CLARIFICATION#1 AGAINST TENDER # PROC-SERVICES/CB/P&P-4678/2020
HIRING OF SERVICES FOR EXECUTION OF ATA-2020 JOBS AT SINJHORO GAS FIELD

Following Clarifications has been made in the subject tender.

8" HELICAL COIL

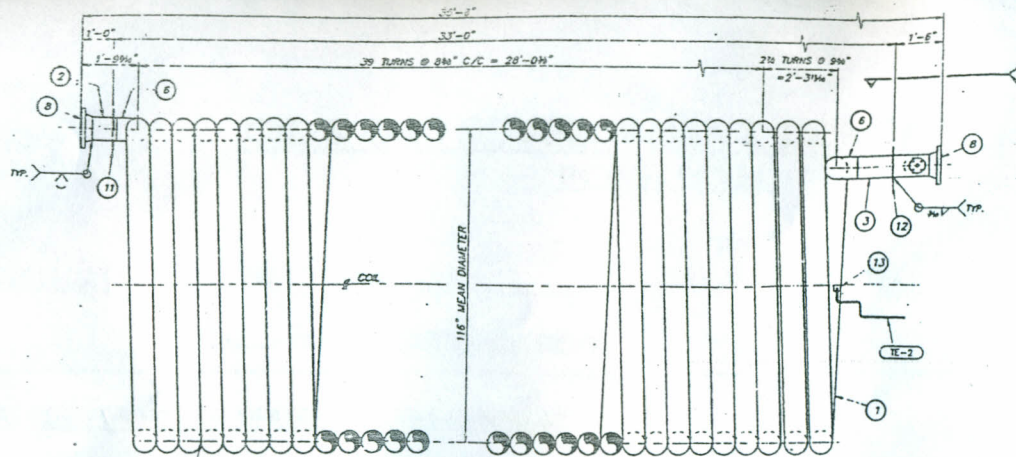
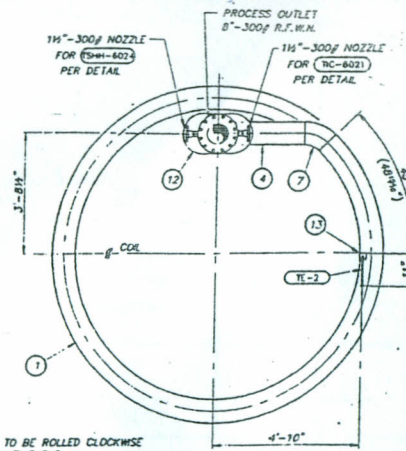
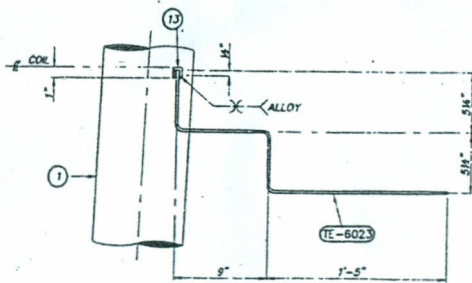
7	Client to share tentative structure scope (weight) against all structure related jobs.	N/A
8	As per ITB Contractor has the scope of replacement of Hot Oil Heater Coil (coil size 10ft dia and 38ft length). Client to share drawings.	Drawing attached.
9	Client to specify jobs which require hydraulic tightening.	Mercury Guard Bed, Molecular Sieve and Separator Jobs require hydraulic tightening.
10	Client to confirm whether compressed air will be supplied in plant area?	Yes, will be provided.
